November 11, 2015
BOARD OF COUNTY COMMISSIONERS
ORANGE COUNTY, FLORIDA
Y16-713-CC / ADDENDUM #1
JOHN BRIDGES COMMUNITY CENTER BUILDINGS D & F HVAC REPLACEMENT

Orange County John Bridges Community Center Buildings D & F HVAC Replacement

SHEET INFORMATION:	
JOB No. 100045178	Date Issued: OCTOBER 25, 2015
Designed By: LF	Sheet Number:
Checked By: FL	ED-102
OC Review: GFH	
Phase:

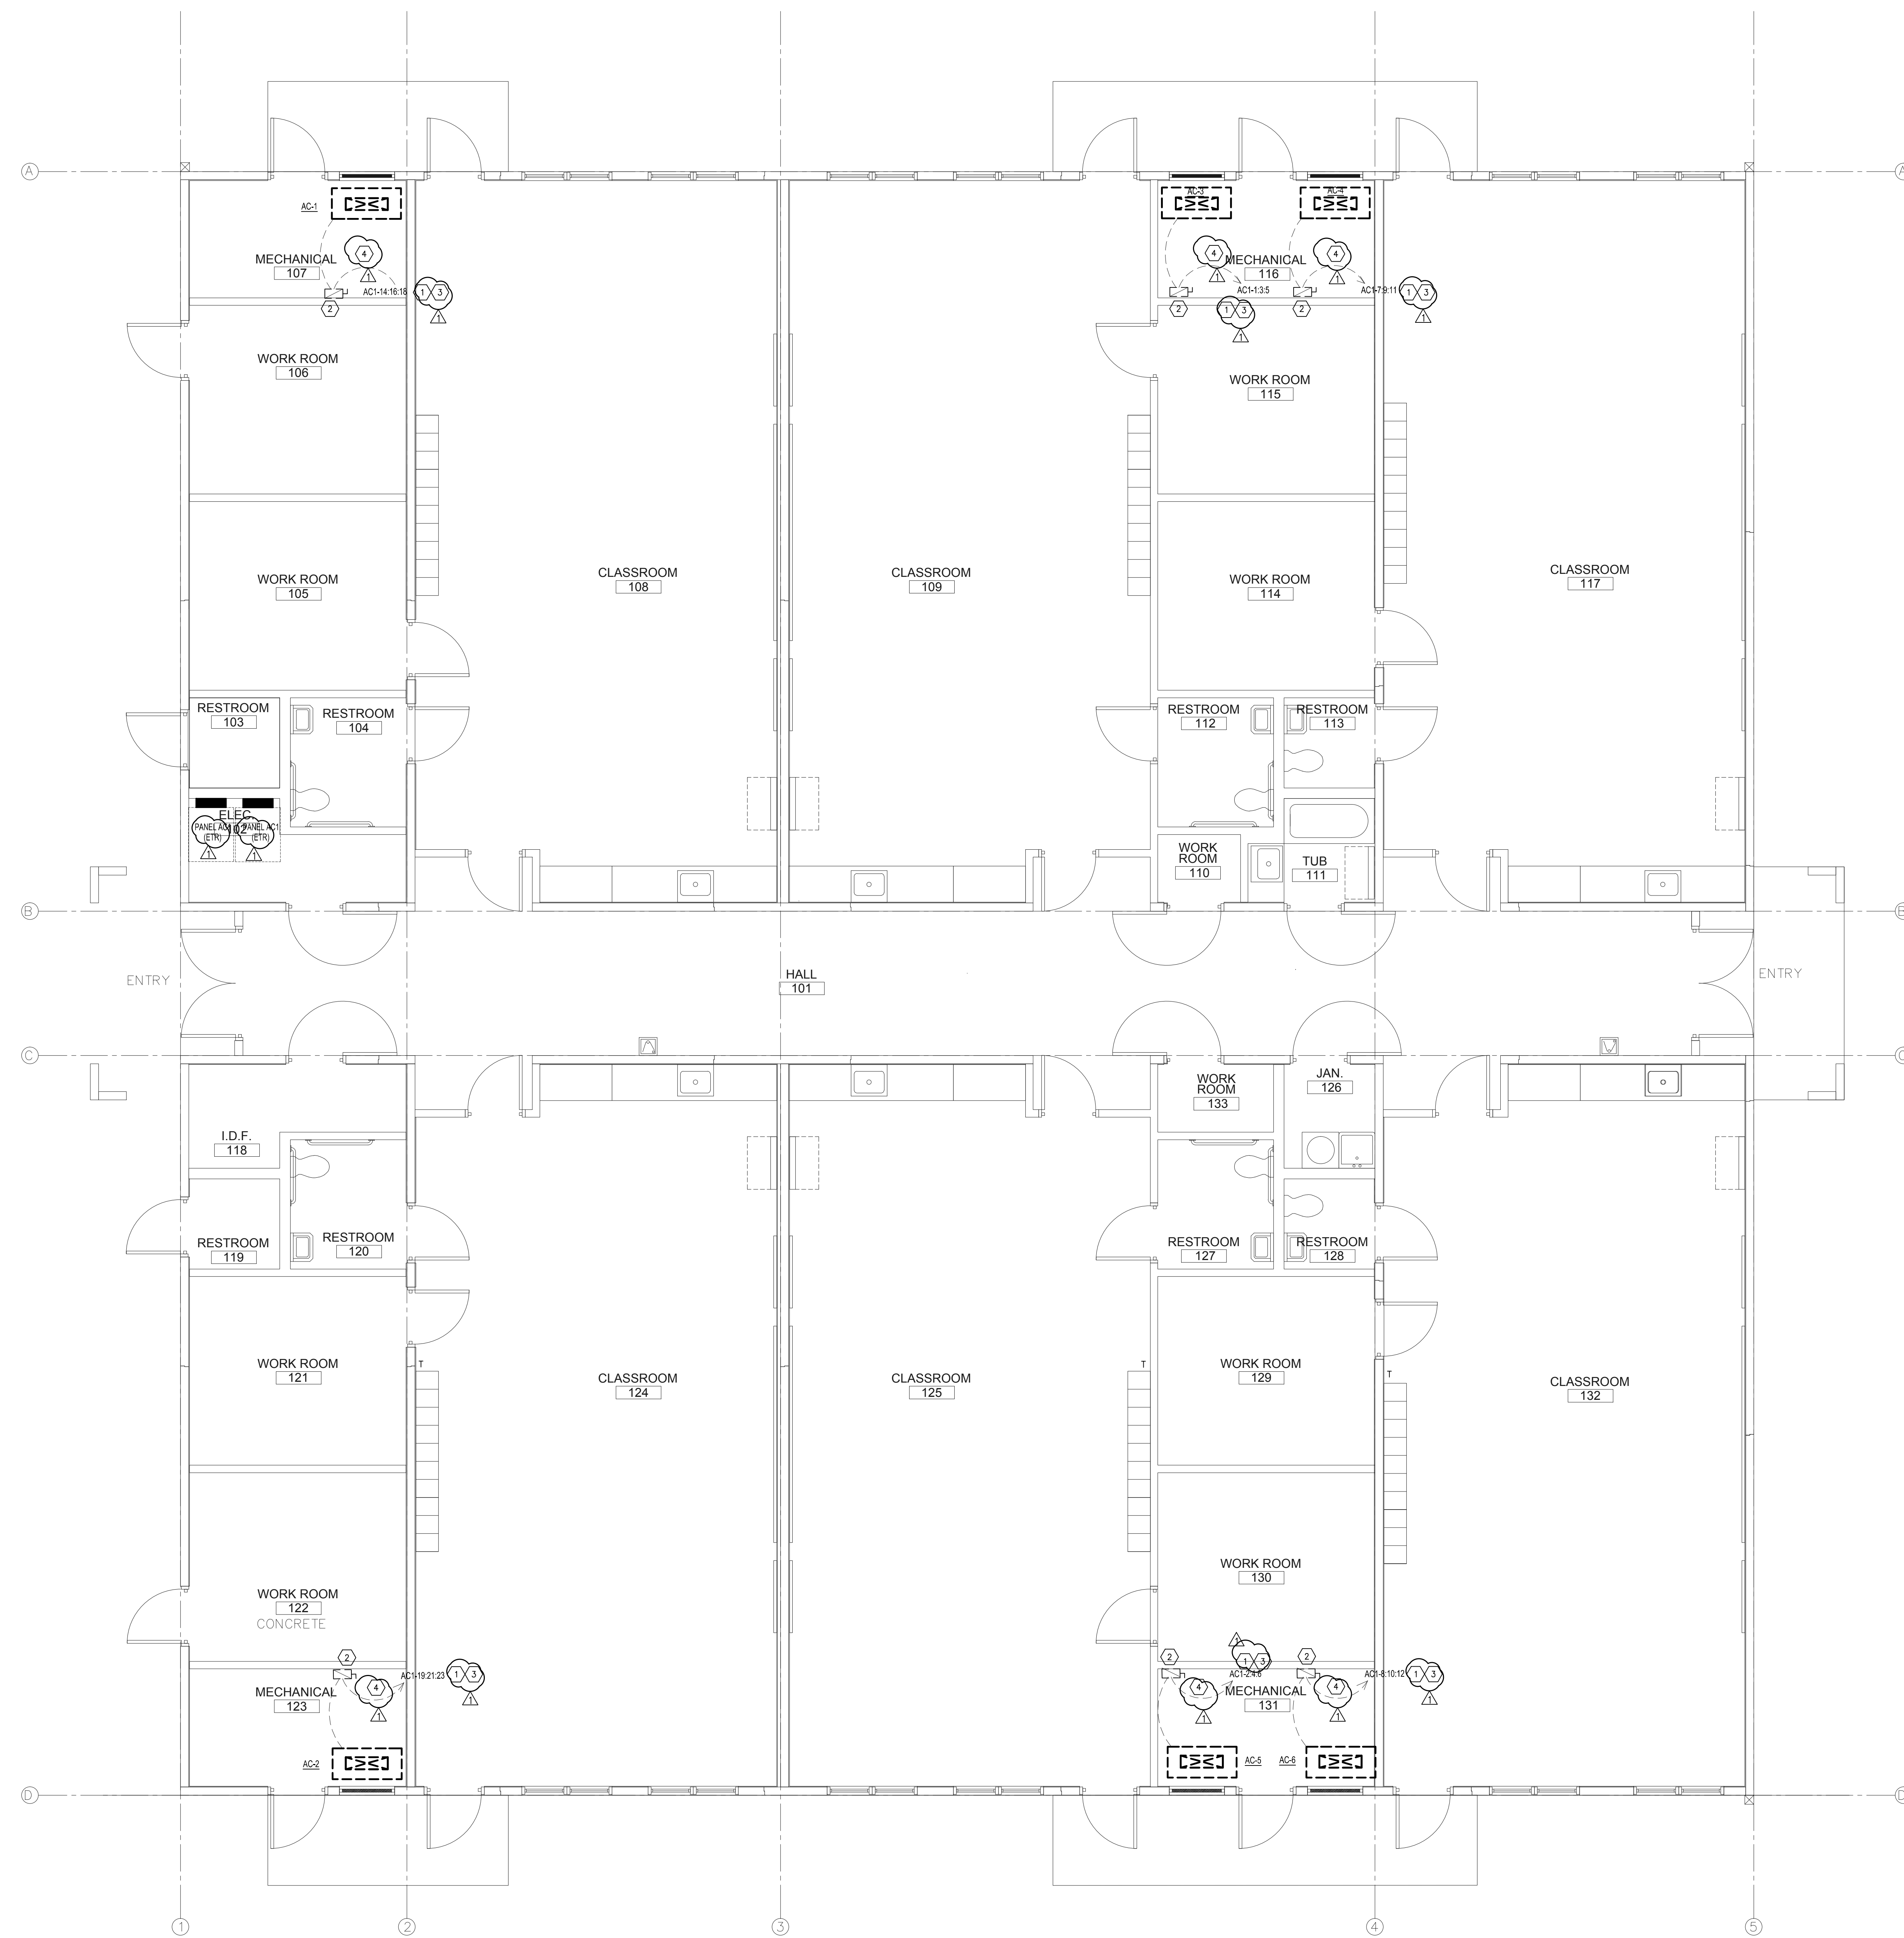
- ED-101 -Text font was made consistent,
-clarified Sheet Notes and Keyed Notes.
- ED-102 -Text font was made consistent,
-clarified Sheet Notes and Keyed Notes.

SHEET INFORMATION:	
JOB No. 100045178	Date Issued: OCTOBER 25, 2015
Designed By: LF	Sheet Number:
Checked By: FL	
QC Review: GFH	
Phase:	E-101

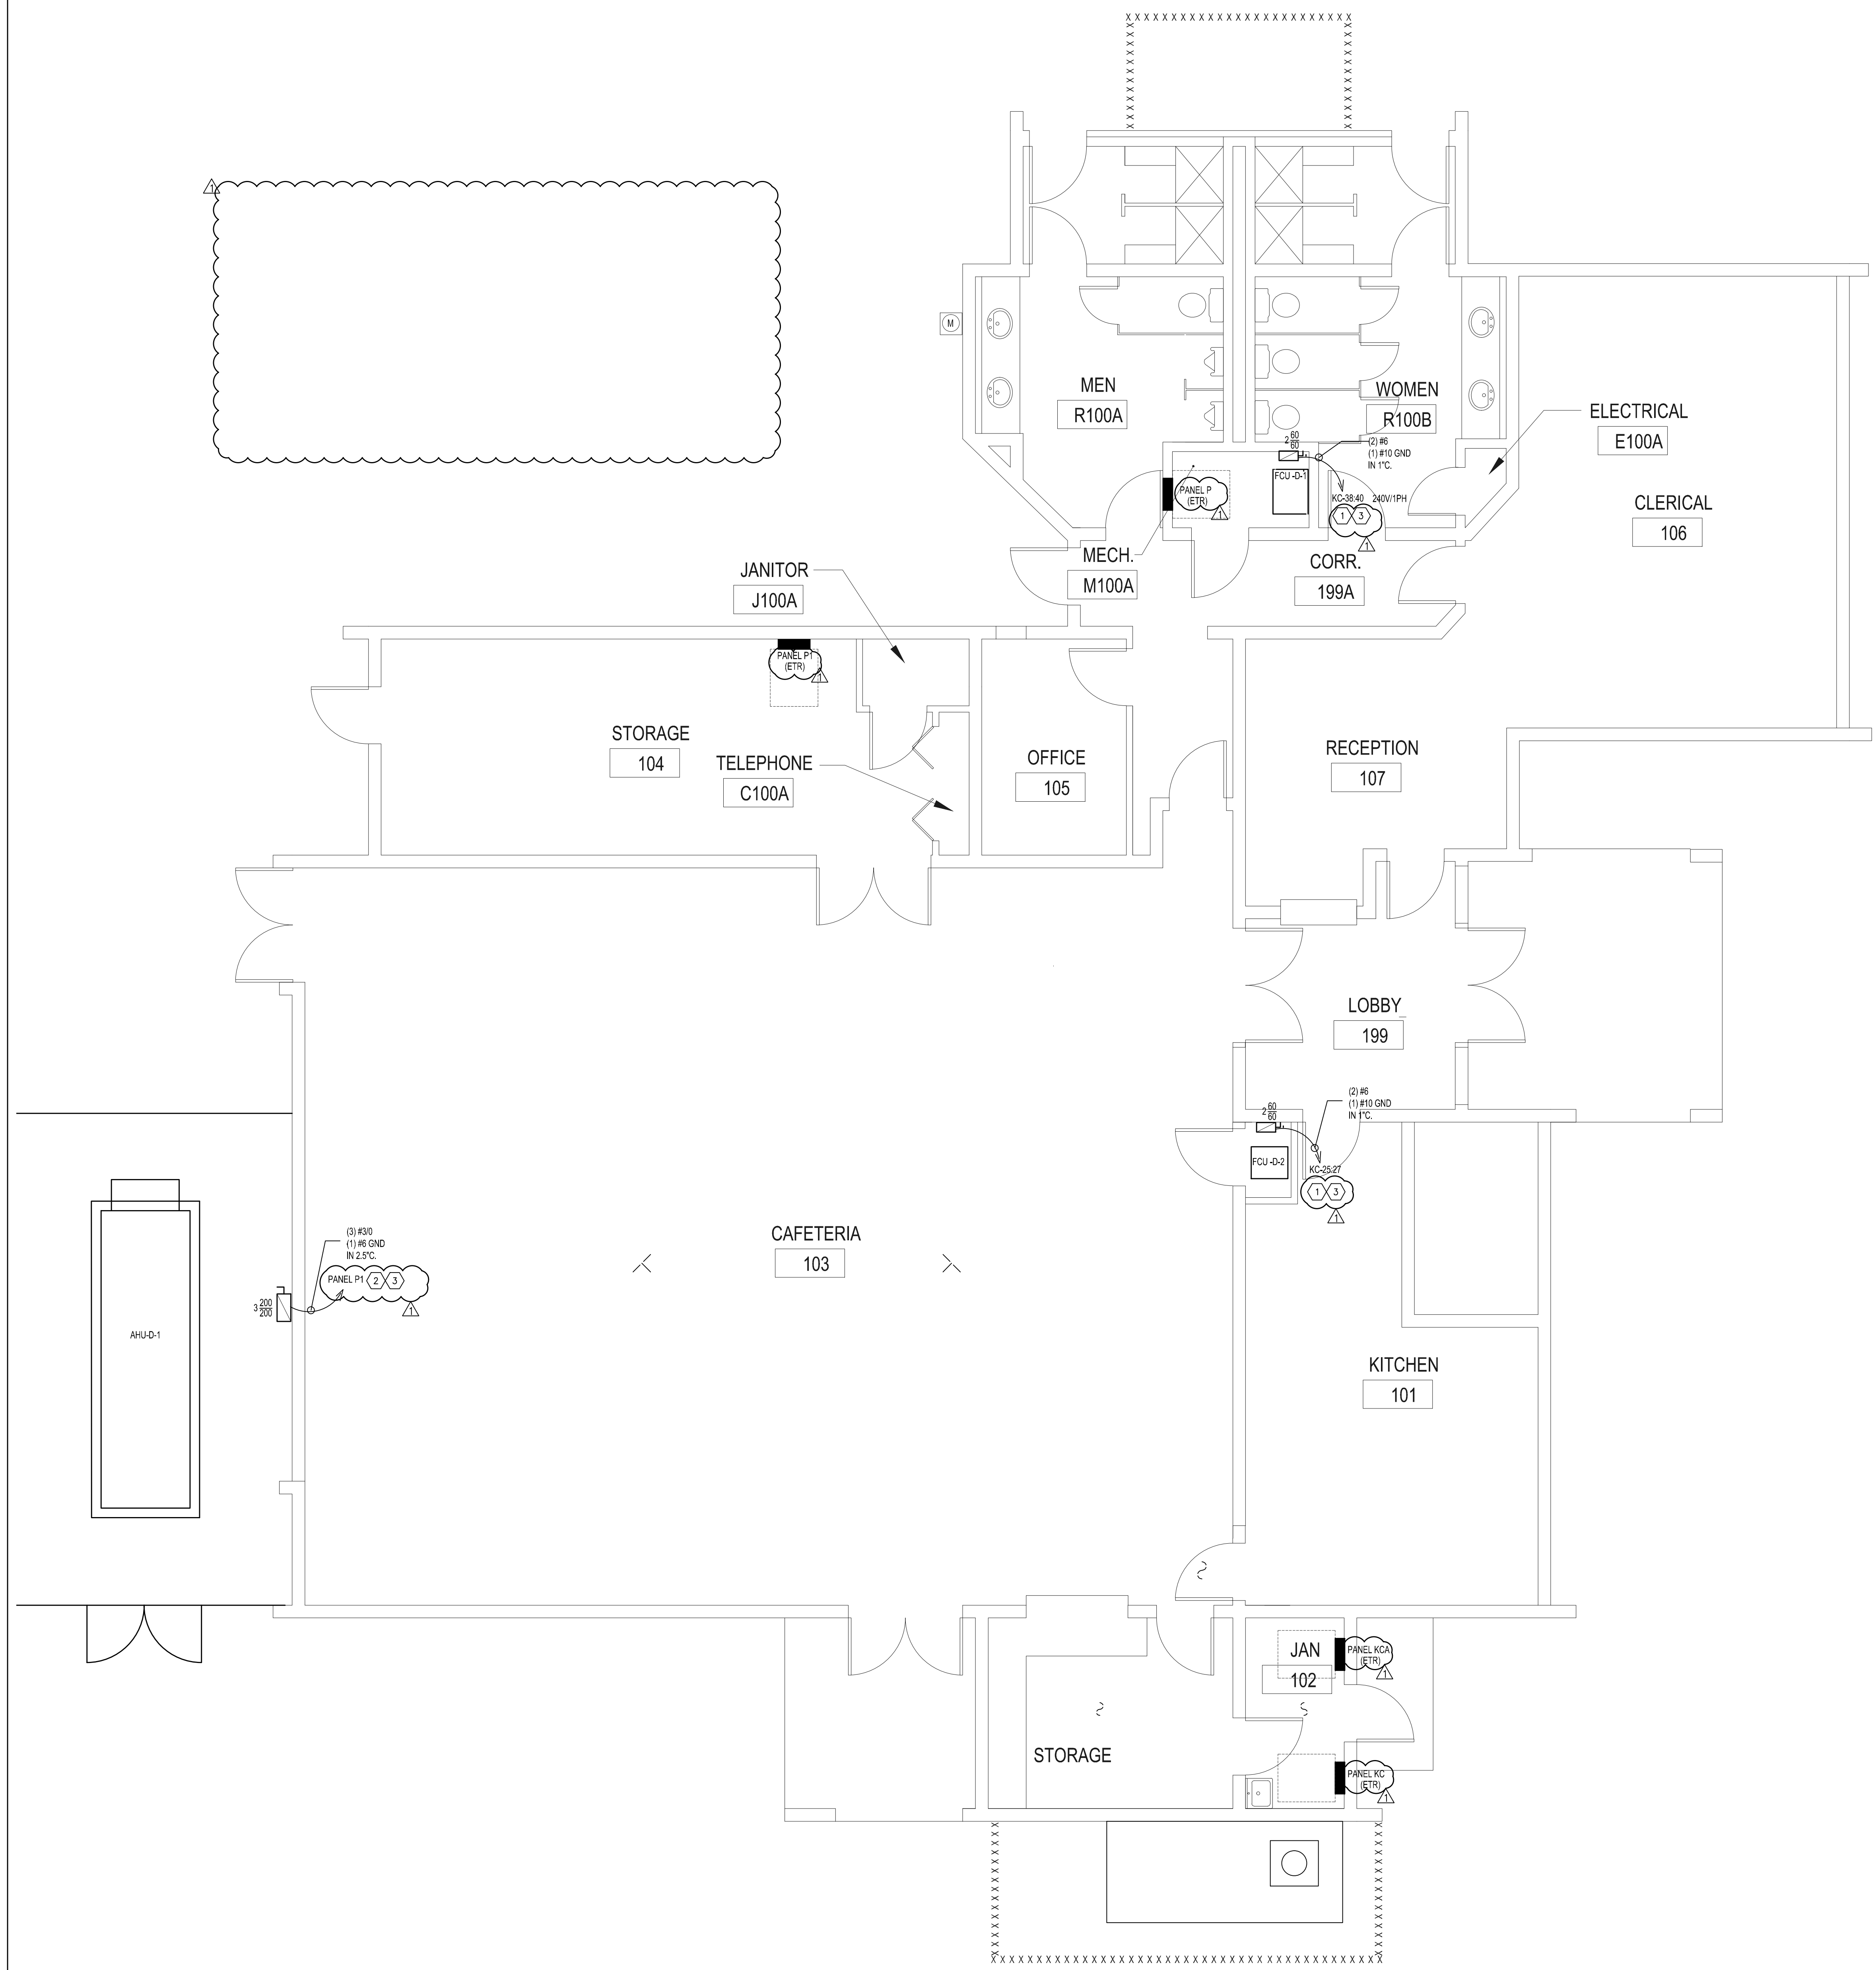
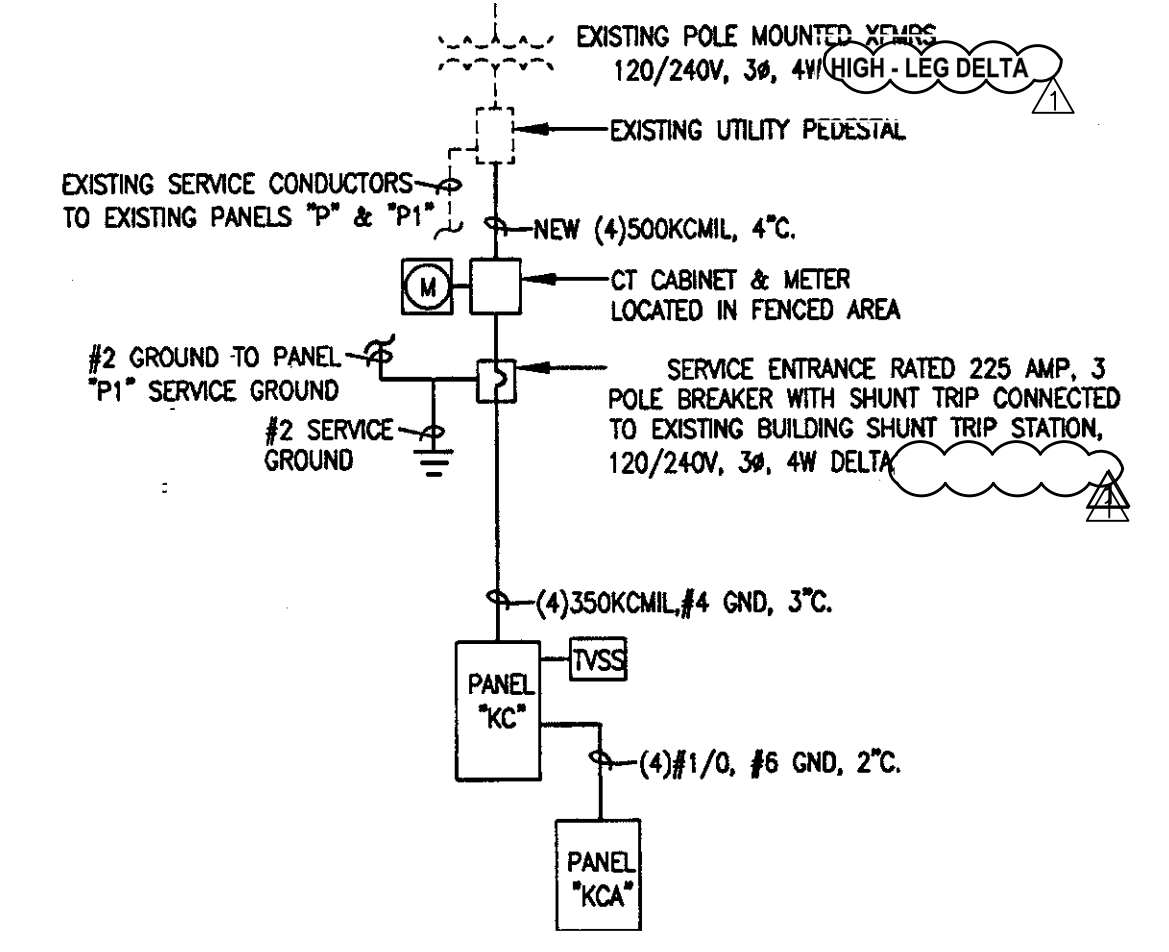
- E-101 -Text font was made consistent,
-clarified Sheet Notes and Keyed Notes,
-revised load summaries for panels KC and KD
- E-102 -Text font was made consistent,
-clarified Sheet Notes and Keyed Notes.

LOAD TYPE	CONNECTED (KVA)
PANEL LOAD 240V/3PH	63.00
PANEL LOAD 240V/1PH	19.90
REMOVED LOAD 240V/1PH	9.90
ADDED LOAD 240V/1PH	20.90
NEW TOTAL LOAD	93.90
PANEL CAPACITY	166.24
PANEL AMPACITY	400 AMPS

LOAD TYPE	CONNECTED (KVA)
PANEL LOAD 240V/3PH	67.00
PANEL LOAD 240V/1PH	66.90
REMOVED LOAD	53.90
ADDED LOAD	74.00
NEW TOTAL LOAD	74.00
PANEL CAPACITY	166.24
PANEL AMPACITY	400 AMPS
